## SUMMARY OF CONCERNS IN RELATION TO THE PROPOSED NORTHCONNEX TUNNEL

This is an objection to many aspects of the proposed NorthConnex tunnel.

## SECTION A: THE CONNECTIVITY OF NORTHCONNEX SOUTHERN VENTILATION FACILITY AT THE SOUTHERN INTERCHANGE, THE SOUTHBOUND TUNNEL IN PARTICULAR

MOTORWAY OPERATIONS COMPLEX - SOUTHERN VENTILATION FACILITY - SECTIONS  
M1-M2-5000-DR-JD-0525

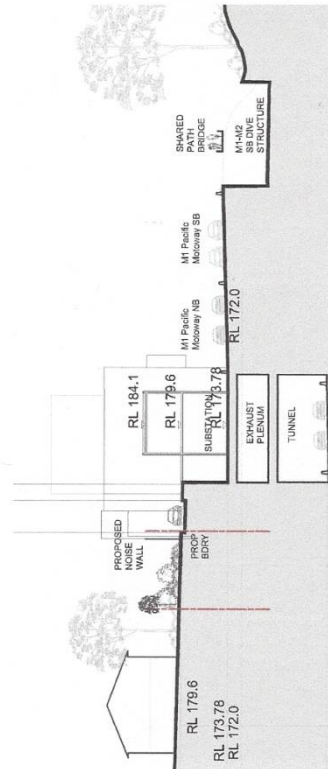
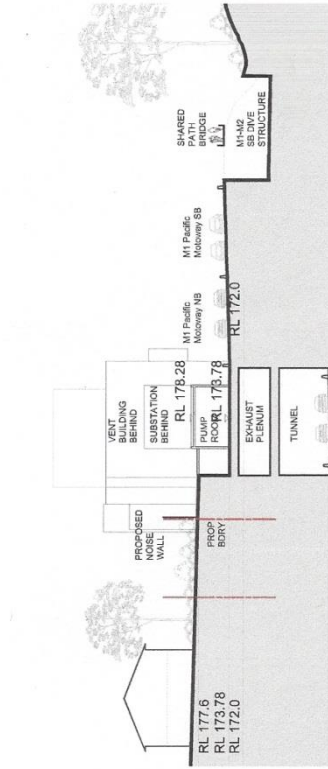
5. *EIS Volume 4, Technical working papers - Urban Design, 6.0 Operational Ancillary Facilities*  
EIS Page 99 there is the diagram "Motorway Operations Complex – Southern Ventilation Facility – sections. *Page 10 below* The diagram has the cryptic label "Connection to tunnel TBC". What does TBC stand for? To be considered? Why is tunnel singular? Which tunnel is the diagram referring to northbound or southbound? There is no diagram showing any connection from the Southern Interchange ventilation facility to either the northbound or the southbound tunnel in any way AND YET ....

- Diagrams need to be provided showing the inter-relation between the shaft, the ventilation outlet and the motorway operations centre with a clear description of what is to be constructed and how it will operate.
- The community needs irrefutable evidence that the polluted air from the southbound tunnel exit portals will not be allowed to flow like an invisible sewer through West Pennant Hills, North Rocks, Carlingford and Beecroft.

MOTORWAY OPERATIONS COMPLEX - SOUTHERN VENTILATION FACILITY - SITE SECTION 1-1  
M1-M2-5000-DR-UD-0713

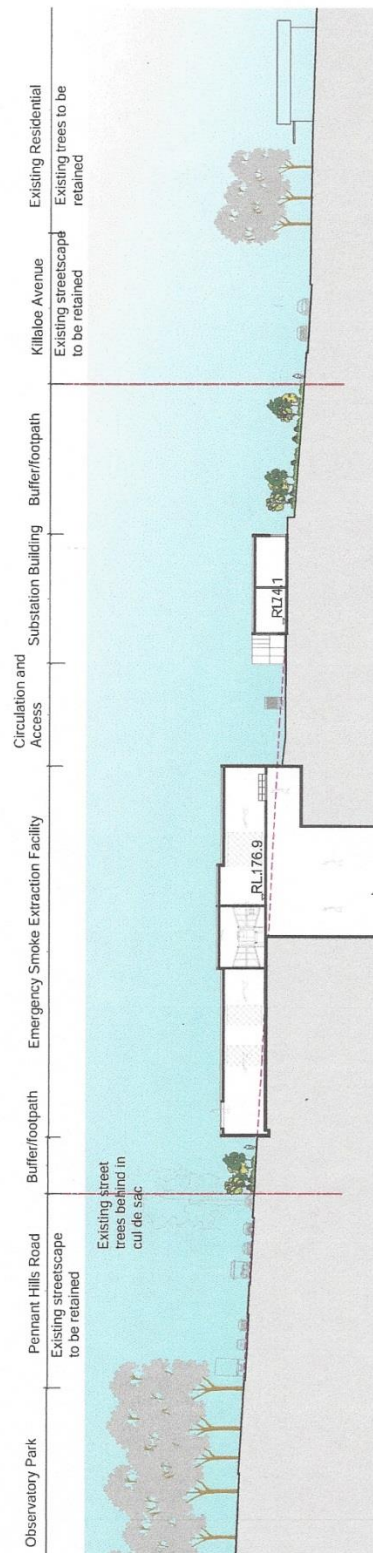
6. *EIS Volume 4, Technical working papers Urban Design, 8.0 Landscape Design*  
EIS Page 176 is the diagram "Motorway Operations Complex – Southern Ventilation Facility – Site 1-1". *Page 13 below* The diagram does not show any connection to either the northbound or southbound tunnel. In the same Landscape Design section, EIS Page 182 is the diagram "Wilson Road Tunnel Support Facility –Section" *Page 14 below* which clearly shows the connection to the tunnels. In the same Landscape Design section, EIS Page 189 is the diagram "Northern Ventilation Facility – Landscape Concept Section". *Page 15 below* This also clearly shows the connection to the tunnels.
